Planning and Development Department

February 9, 2007

Re: **Skylark Commons Subdivision (Ref 87 Skylark Road)**
Application #2004-0252; CBL#347 D001

C2

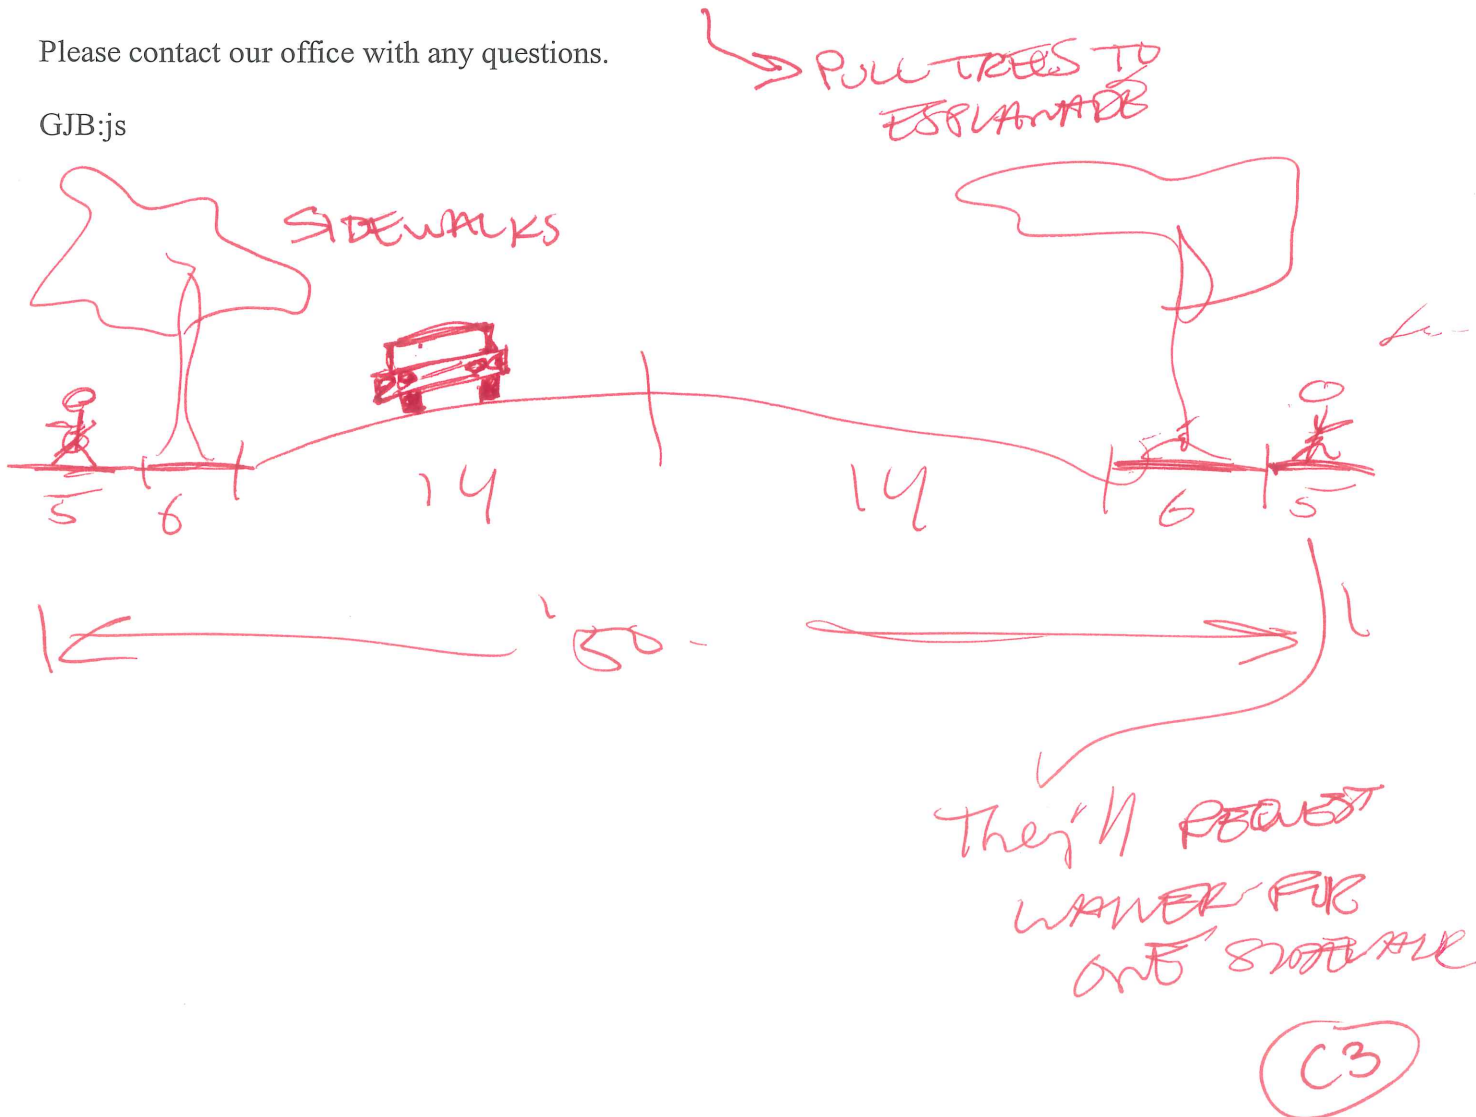
- C. Under drains should be shown in the profile views of the roadways.
↳ BOTH SIDES OF STREET.
- D. Although more wetland will be disturbed, the utility crossing on lots 10 and 11 should be moved into the City Right-of-Way or Oramell Avenue. This will negate the need for a 20-foot utility easement on these lots.
